**Reference** 24/0263/MFUL

**Location** Former Council Offices Knowle Sidmouth Devon EX10 8HL

**Proposal** Redevelopment of site to provide: (a) Care home building (Class C2) with associated parking, landscaping, staff and resident facilities and associated works (b) Extra care apartment building (53 units) with associated communal lounge, wellbeing suite, restaurant and care provision (class C2) (c) Retirement living apartment building (33 units) with associated communal lounge (Sheltered housing) and (d) Erection of 4 houses and 3 townhouses (Class C3) along with accesses, internal car parking, roads, paths, retaining walls, refuse and landscaping associated with development; retention/refurbishment of building B, erection of habitat building and sub-stations. (Demolition of buildings other than building B) (Variation to previous application (23/0571/MFUL) showing removal of balconies and elevational changes to west elevation of Retirement Living block, and alterations to the southern end/ elevations of the Retirement Living and Extra Care buildings)

**RECOMMENDATION: Resolution to approve with conditions, subject to the completion of a legal agreement and adoption of the appr

West Elevation Proposed Re-design

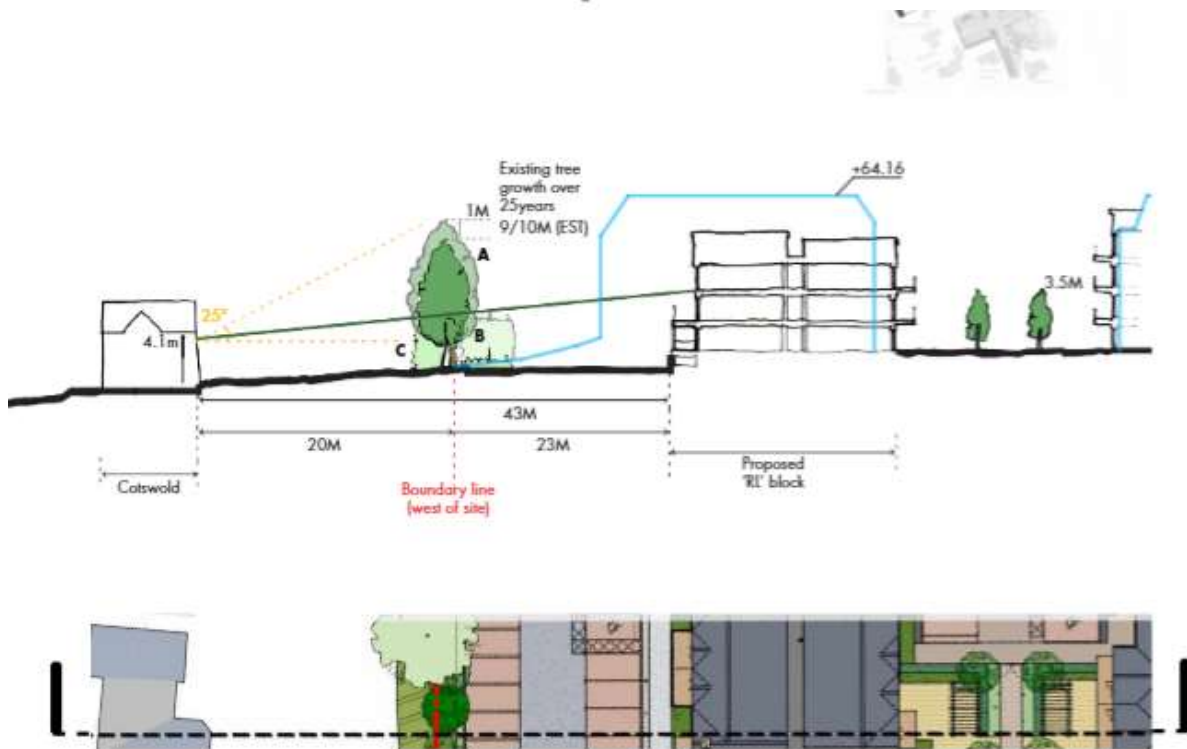
Whilst the ends of these adjacent gardens are situated relatively close to this block of accommodation the neighbouring dwellinghouses themselves are approximately in excess of 40 metres away from the proposed buildings. At these distances, whilst it is a balanced consideration, unacceptable harmful levels of overlooking are not likely to occur. There is no set distance in terms of policy or guidance to establish whether harmful levels of overlooking occur. Often a separation distance of 21.5 metres is relied upon but this is more reflective of an industry standard, rather than routed in policy. Different situations are dependent on their own circumstance. Further, whilst it is often the case that overlooking can occur it is whether *harmful* levels of overlooking would occur to the detriment of one's privacy. Within built up areas it is normal for some level of overlooking to occur between neighbours.

The balconies and windows on the south and west facing face of the western most block provide views to the west. In response to the previously refused scheme a number of the balconys were removed from this west facing elevation.
